# **Drainage Letter**

**Lot 1, Meadow Lake Airport, Filing No. 10  
(a.k.a. 8136 Cessna Drive, Peyton, CO 80831)**

Add PCD File No.  
PPR-19-044

RE: Final Drainage Letter for Lot 1, Meadow Lake Airport, Filing 10, in El Paso County, Colorado.

SHEET NO. <b>1 OF 1</b>	<b>TOM SHAFFER</b> <b>HANGAR STORAGE FACILITY</b> <b>EXHIBIT 2</b>		PH: 19-1 DATE: AUG 2019	DESIGNED BY: JS DRAWN BY: JJS CHECKED BY: JJS		<b>CCP, LLC</b> 14255 JUDGE ORR RD, PEYTON, CO 80831

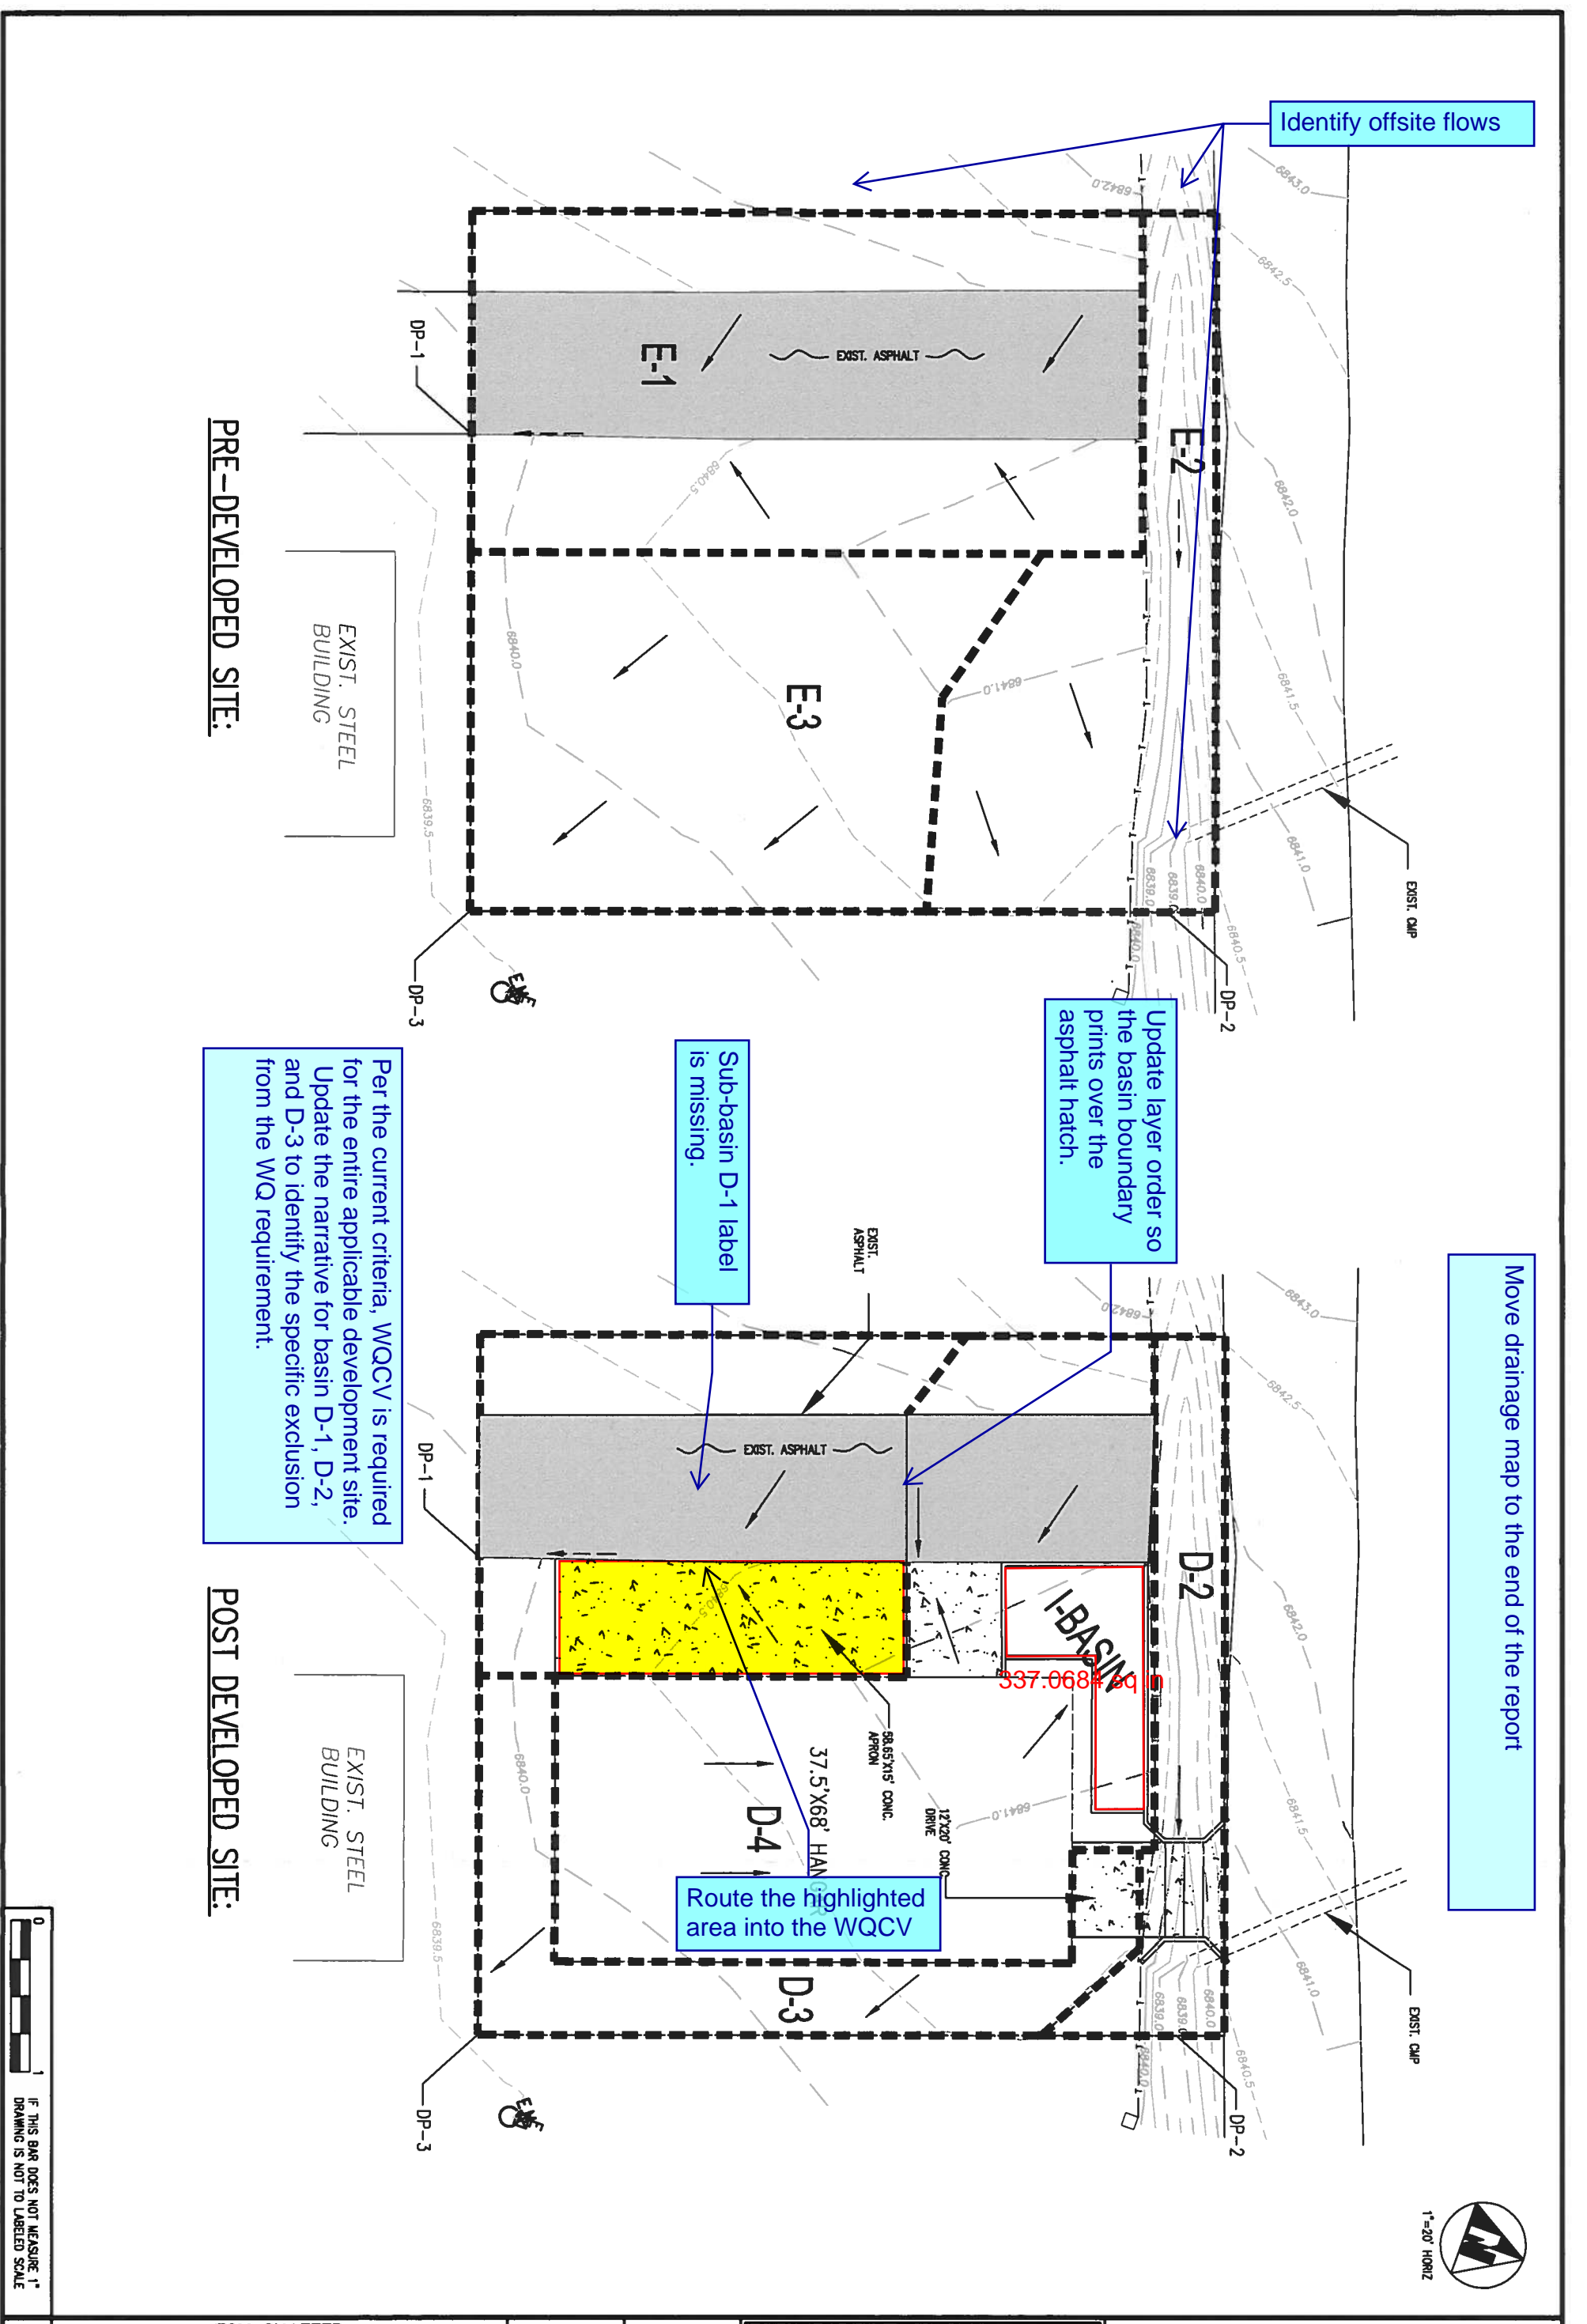
Identify offsite flows

Update layer order so the basin boundary prints over the asphalt hatch.

Sub-basin D-1 label is missing.

Per the current criteria, WQCV is required for the entire applicable development site. Update the narrative for basin D-1, D-2, and D-3 to identify the specific exclusion from the WQ requirement.

Move drainage map to the end of the report

Route the highlighted area into the WQCV

### OFFSITE DISCHARGE CALCULATIONS

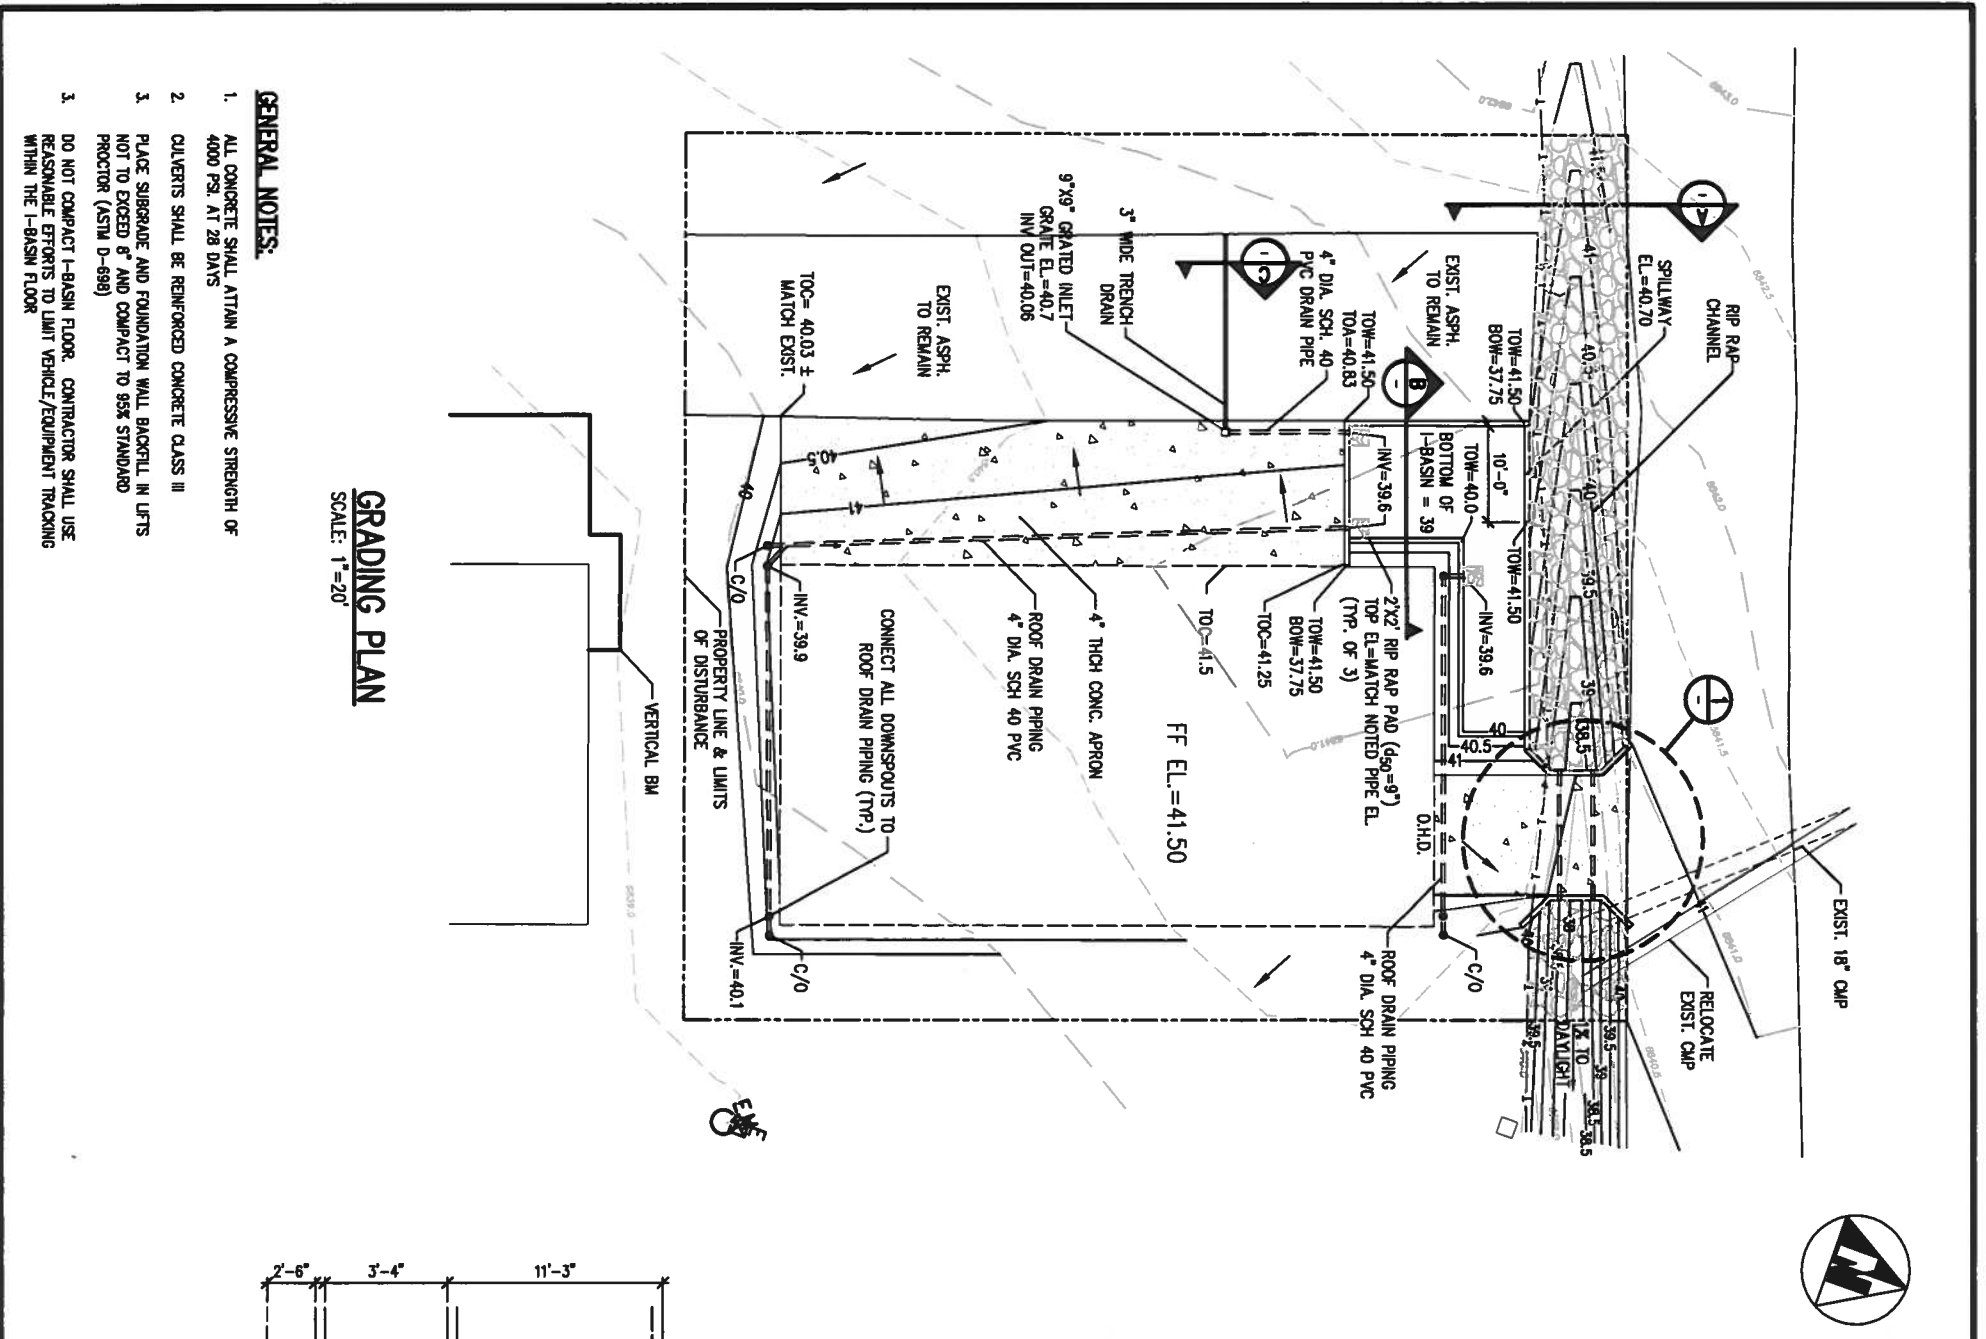
Provide a sub-basin ID and show on the drainage map
